VILLAGE OF SALADO, TEXAS

0.200 MGD WASTEWATER TREATMENT PLANT

ADDENDUM NO. 4

November 10, 2017

VILLAGE OF SALADO, TEXAS
0.200 MGD WASTEWATER TREATMENT PLANT
TYPE "305" ALTERNATE CANOPY
FRAMING PLAN / DETAIL

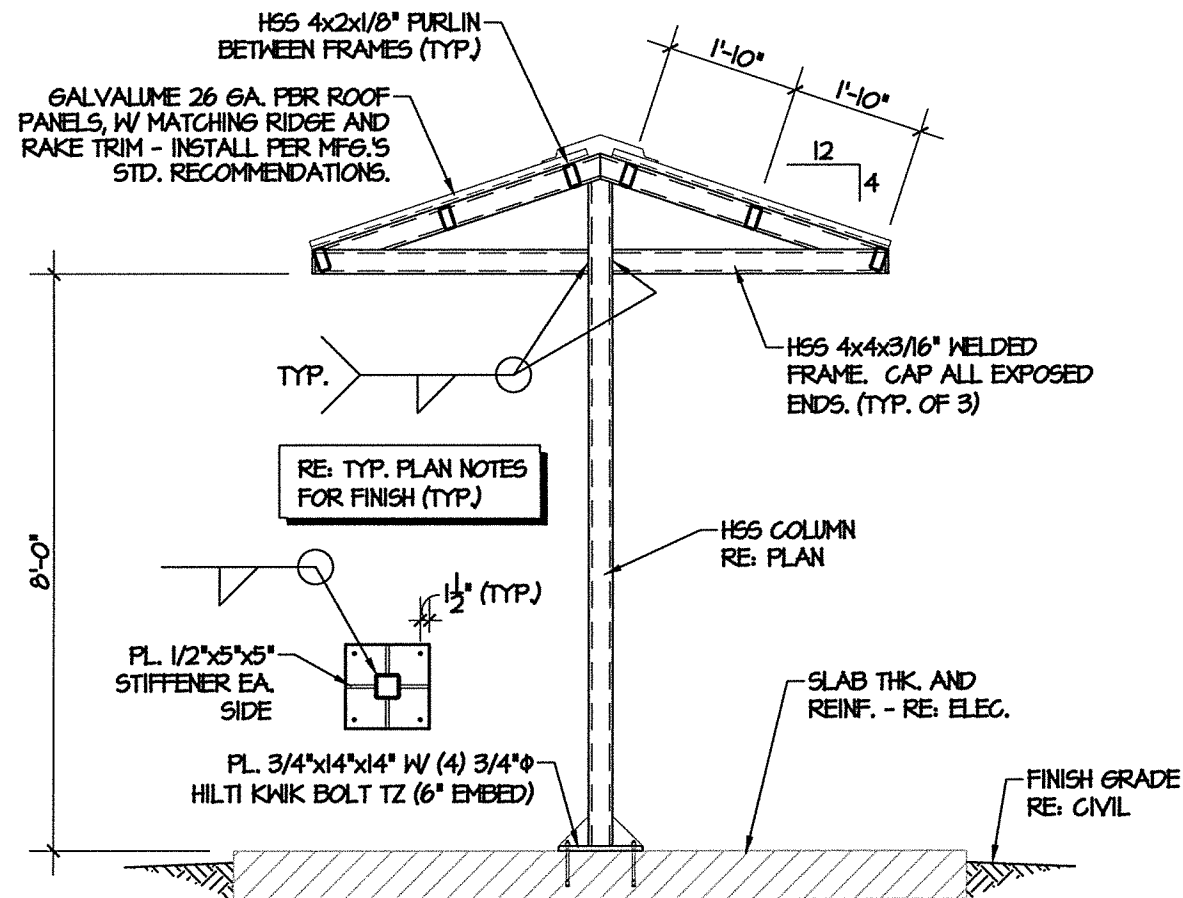
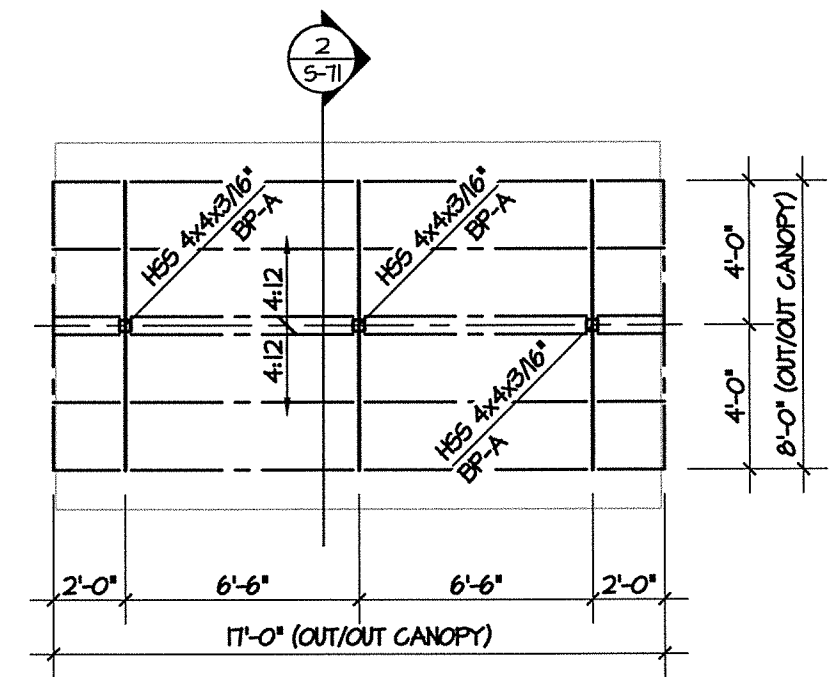
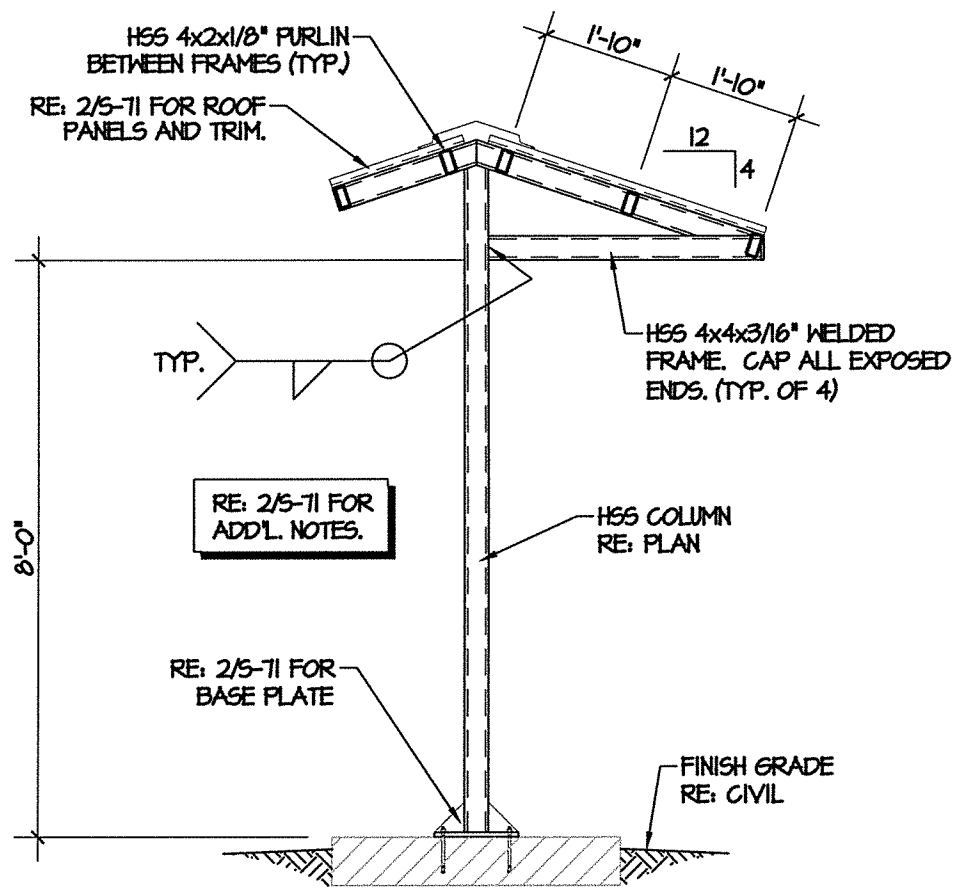
1. Refer to Sheet G-01. Add Sheets S-71 – TYPE “305” ALTERNATE CANOPY FRAMING PLAN/DETAIL and S-72 – TYPE “404” ALTERNATE CANOPY FRAMING PLAN/DETAIL to the Index of Sheets. The Contractor may substitute the pre-fabricated canopies with built in place canopies. Attached are additional Sheets S-71 and S-72 which include details for built in place canopies.

1. Refer to the Canopy Details 305 and 404 shown on Sheets EL 20 and EL 21 respectively. The Contractor may substitute the prefabricated canopies with built in place canopies. Attached are additional Sheets S-71 and S-72 which include details for built in place substitute canopies 305 and 404.
